**COMMERCIAL REVIEW**

**1450 SE BROADWAY  
LEES SUMMIT, MISSOURI**

RIGHT ELEVATION  
3/16" = 1'0"

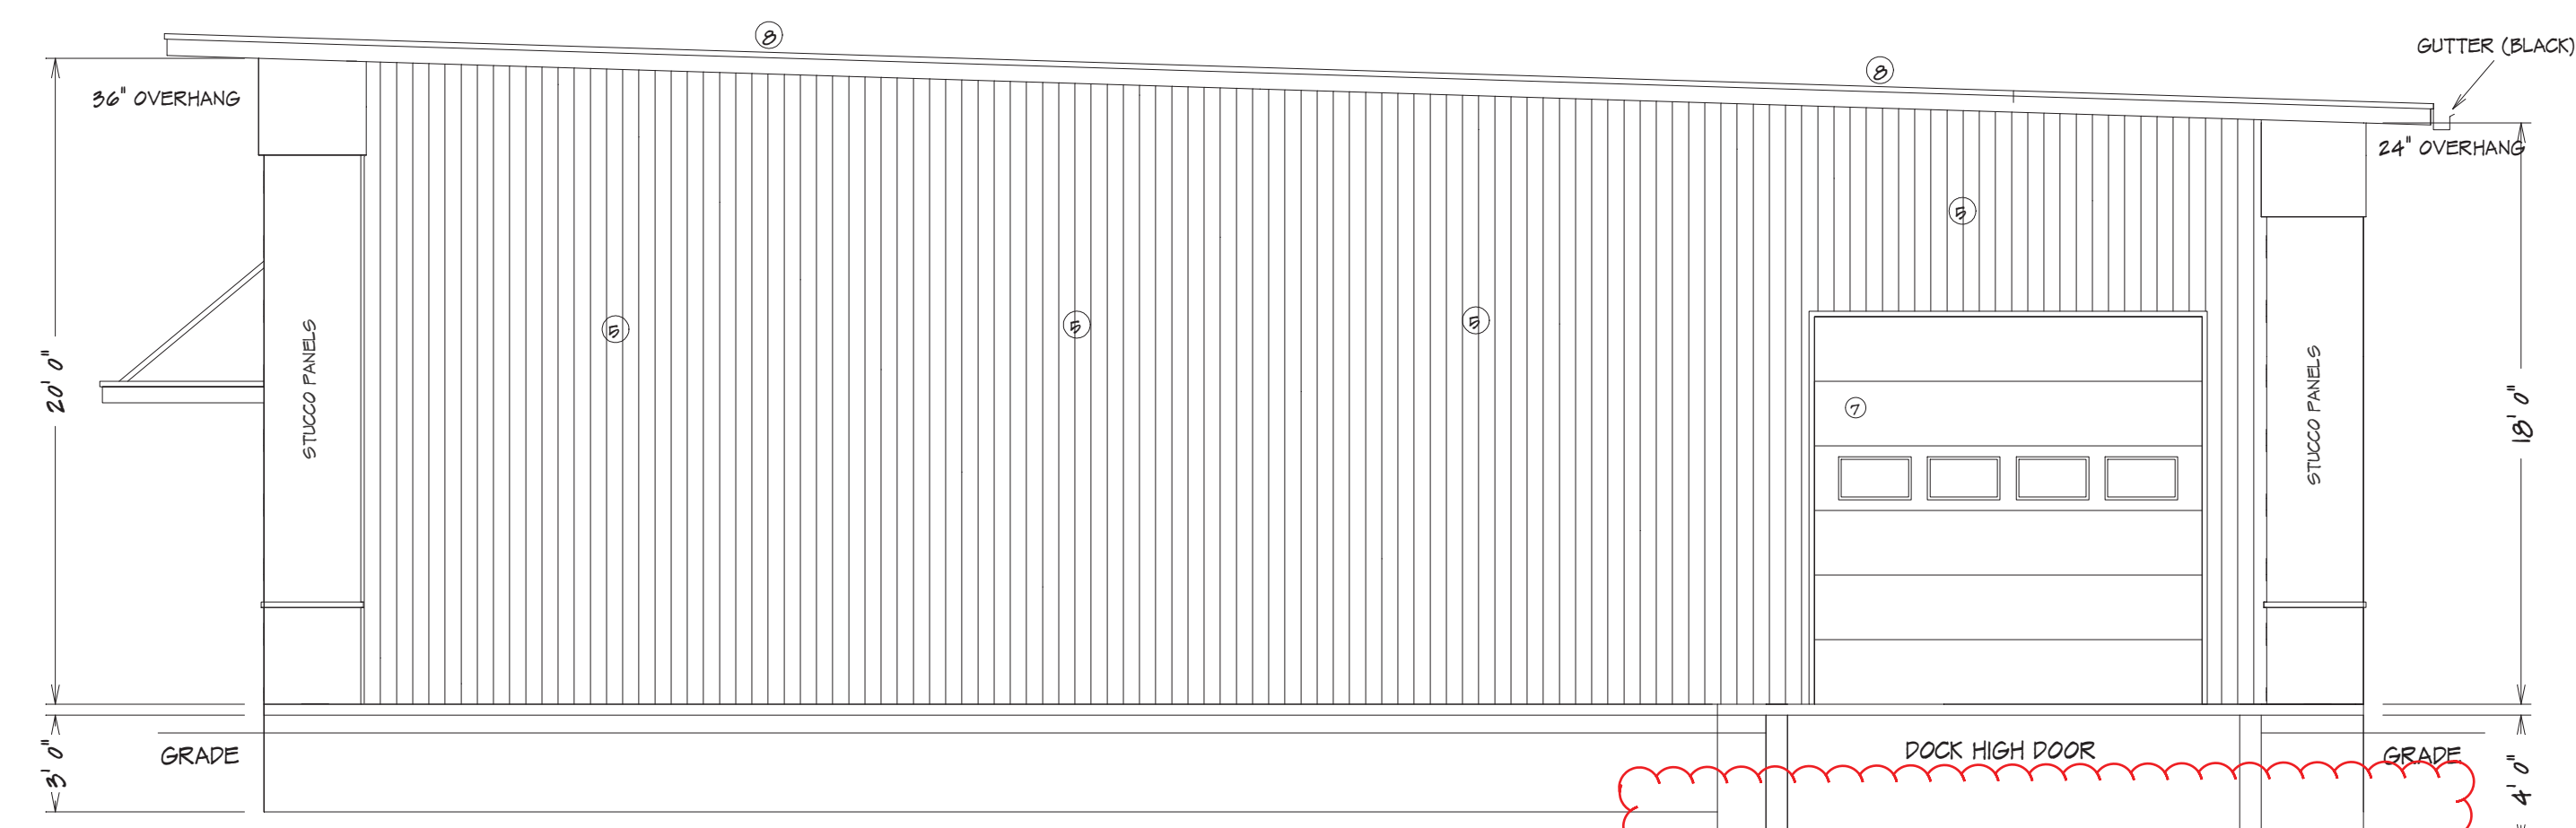
RETAINING WALL FOOTING TO EXTEND BELOW FROST LINE MIN DEPTH 36". CONSTRUCTED IN ACCORDANCE WITH ASCE 32  
ITEM# 8

FIRST FLOOR MECHANICAL PLAN  
SCALE: 3/16" = 1'

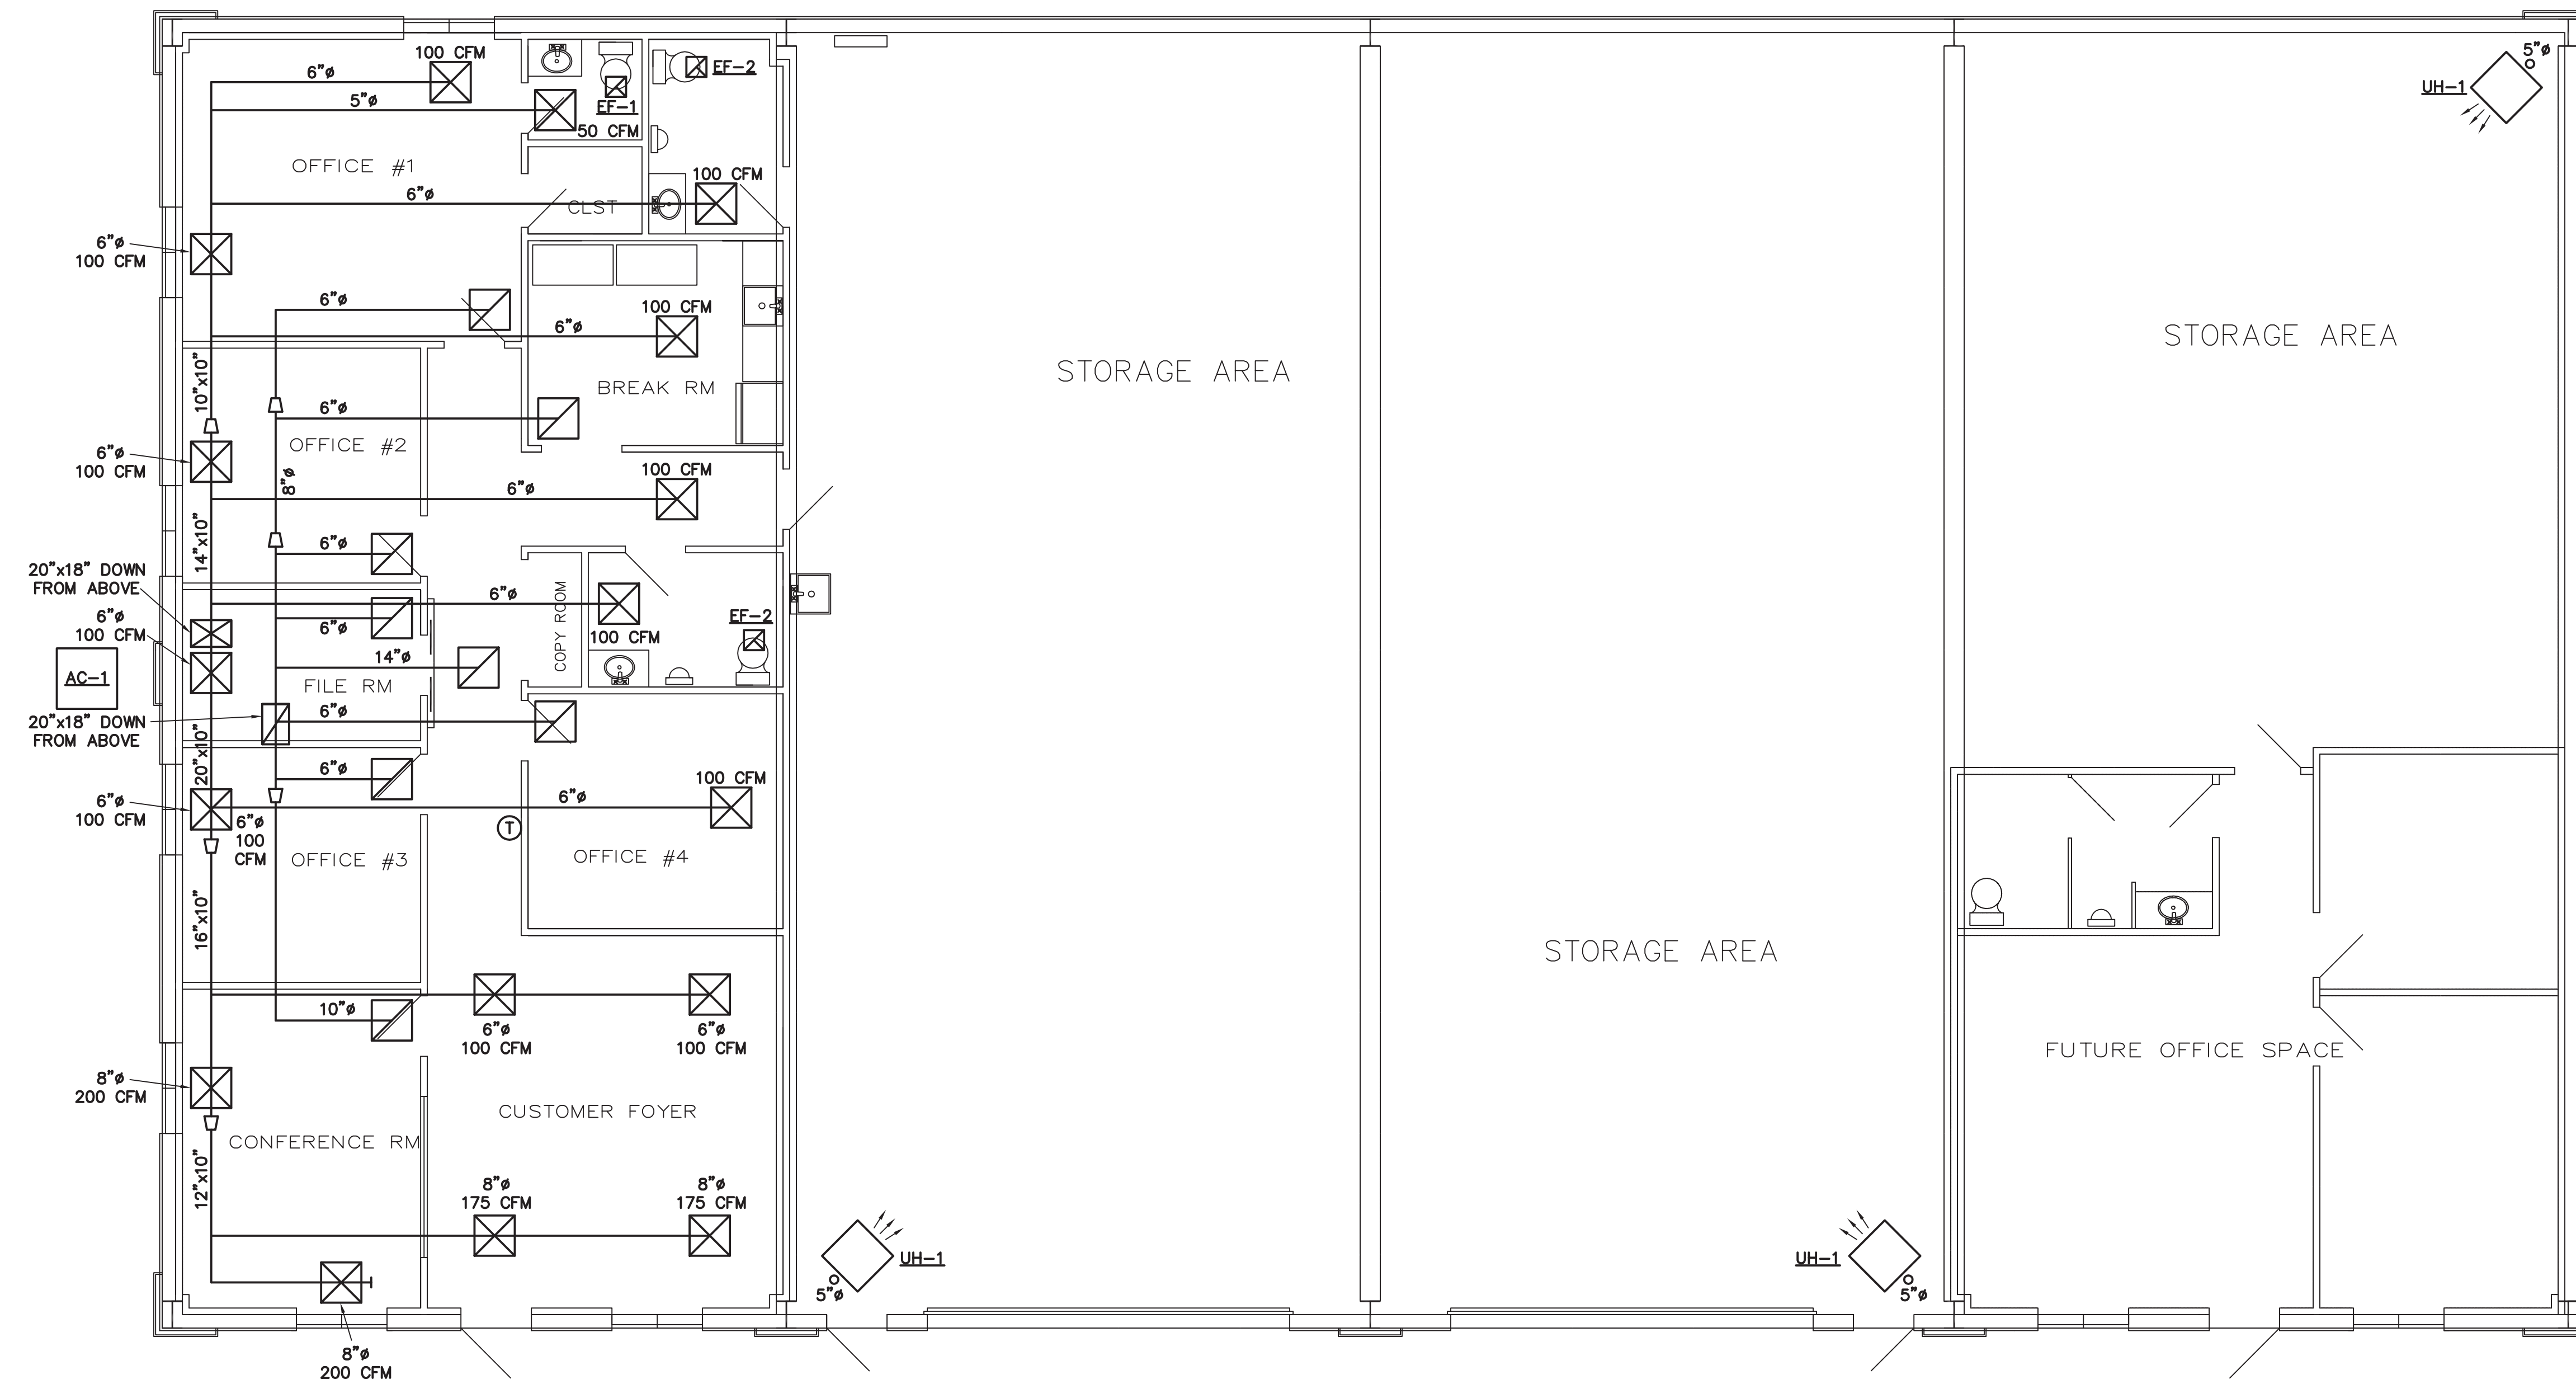
IMC 2012 FRESH AIR REQUIREMENTS
16 PEOPLE AT .5 CFM FRESH AIR PER PERSON = 80 CFM FRESH AIR ADJUST FRESH AIR DAMPER TO 80 CFM
